MYSTERY COVE WATERPARK

DRC OVERVIEW - 2024 CURRENT PLAN

8 May 2024

MOA DEVELOPMENT
EXISTING

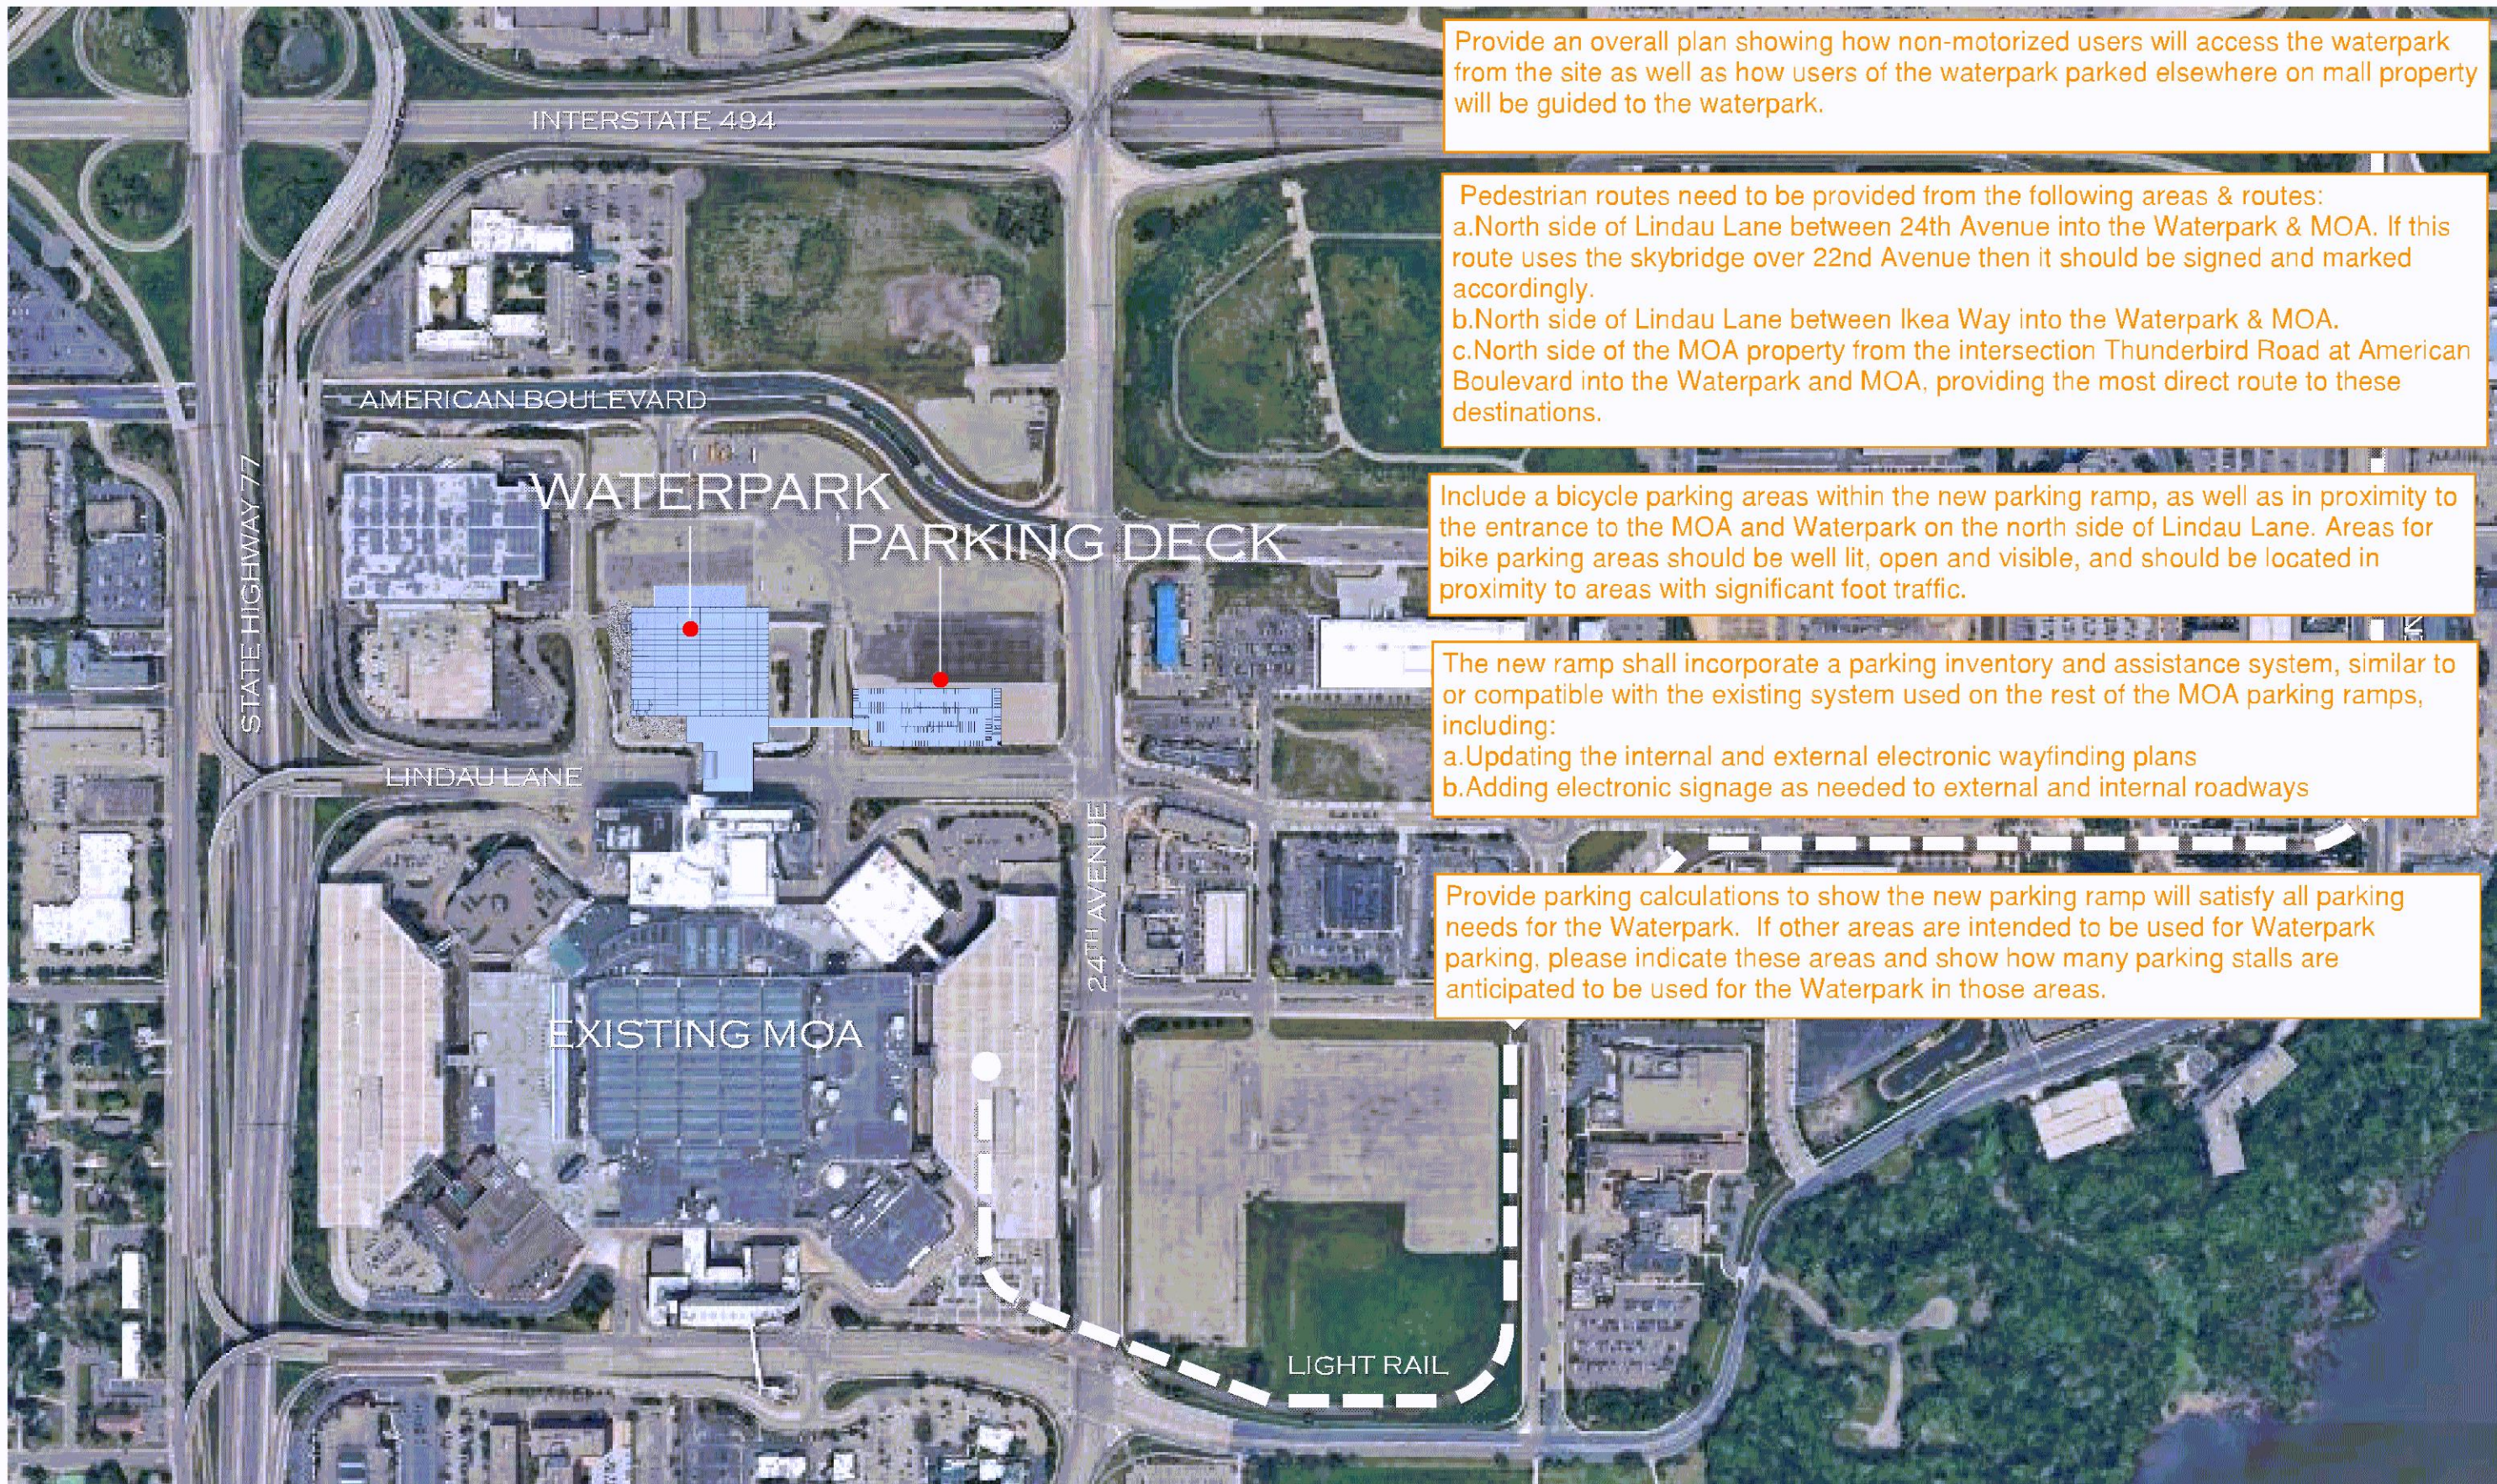
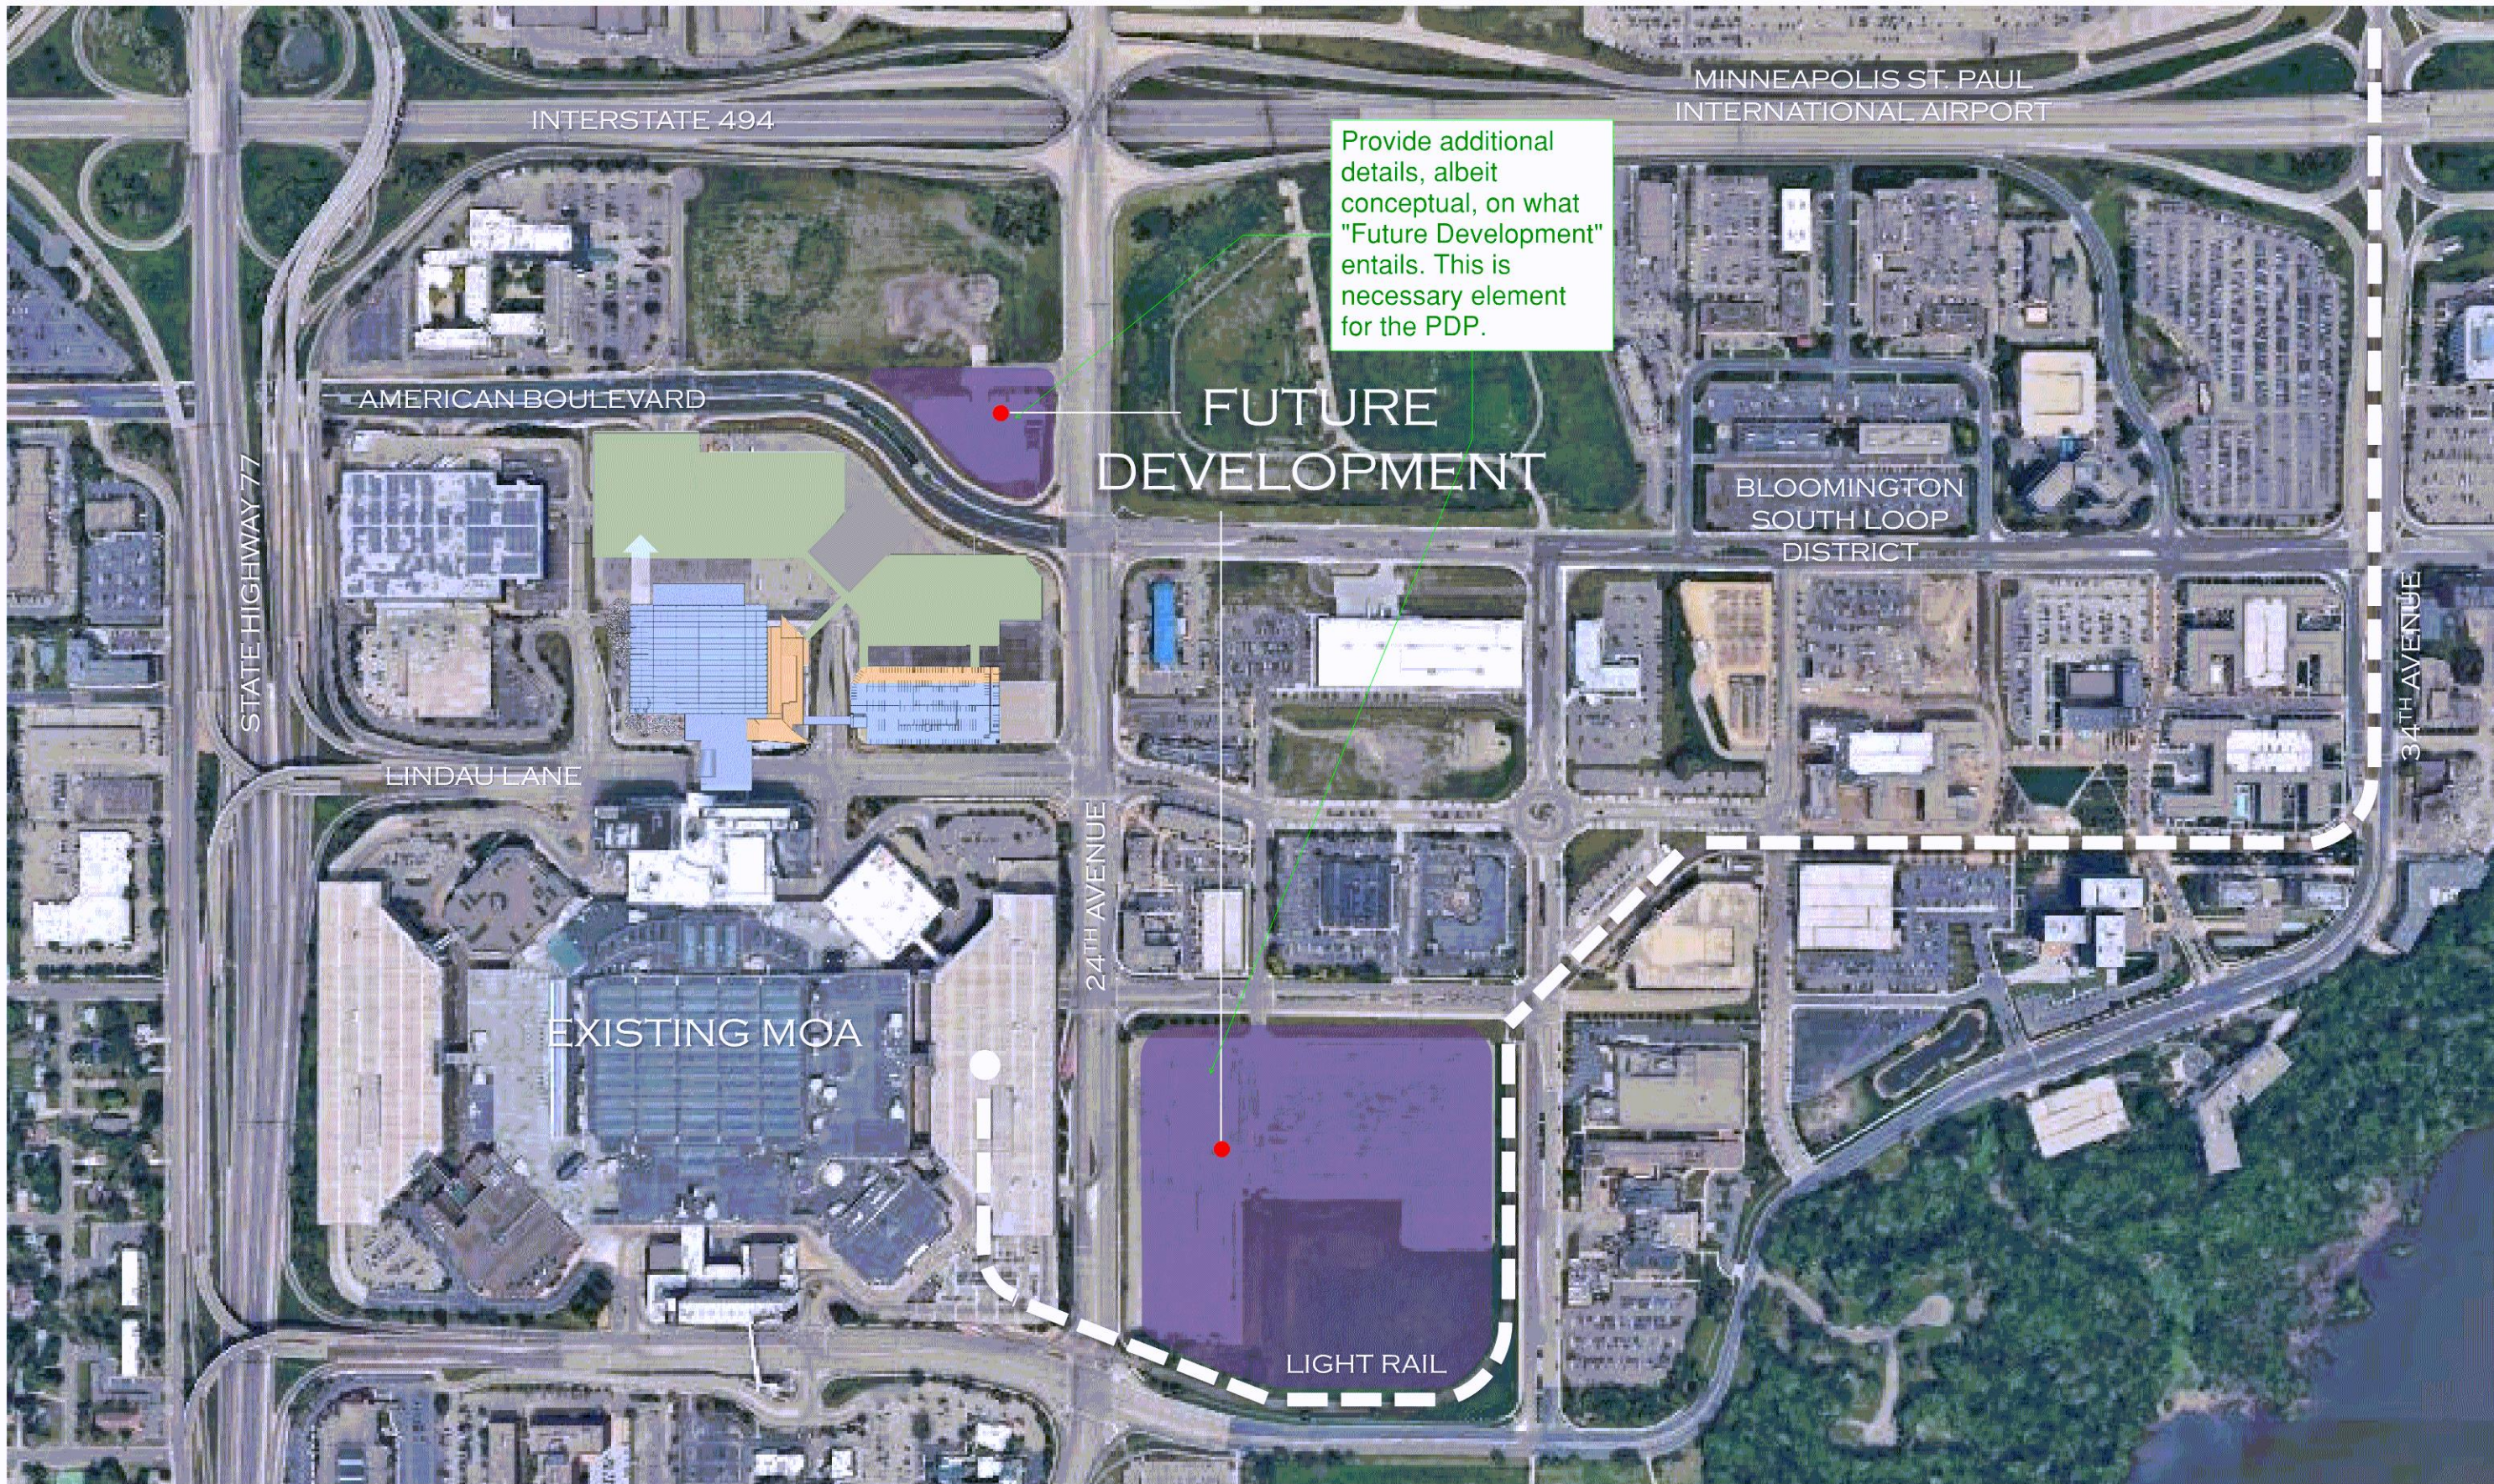
Provide an overall plan showing how non-motorized users will access the waterpark from the site as well as how users of the waterpark parked elsewhere on mall property will be guided to the waterpark.

Pedestrian routes need to be provided from the following areas & routes:
a. North side of Lindau Lane between 24th Avenue into the Waterpark & MOA. If this route uses the skybridge over 22nd Avenue then it should be signed and marked accordingly.
b. North side of Lindau Lane between Ikea Way into the Waterpark & MOA.
c. North side of the MOA property from the intersection Thunderbird Road at American Boulevard into the Waterpark and MOA, providing the most direct route to these destinations.

Include a bicycle parking areas within the new parking ramp, as well as in proximity to the entrance to the MOA and Waterpark on the north side of Lindau Lane. Areas for bike parking areas should be well lit, open and visible, and should be located in proximity to areas with significant foot traffic.

The new ramp shall incorporate a parking inventory and assistance system, similar to or compatible with the existing system used on the rest of the MOA parking ramps, including:
a. Updating the internal and external electronic wayfinding plans
b. Adding electronic signage as needed to external and internal roadways

Provide parking calculations to show the new parking ramp will satisfy all parking needs for the Waterpark. If other areas are intended to be used for Waterpark parking, please indicate these areas and show how many parking stalls are anticipated to be used for the Waterpark in those areas.
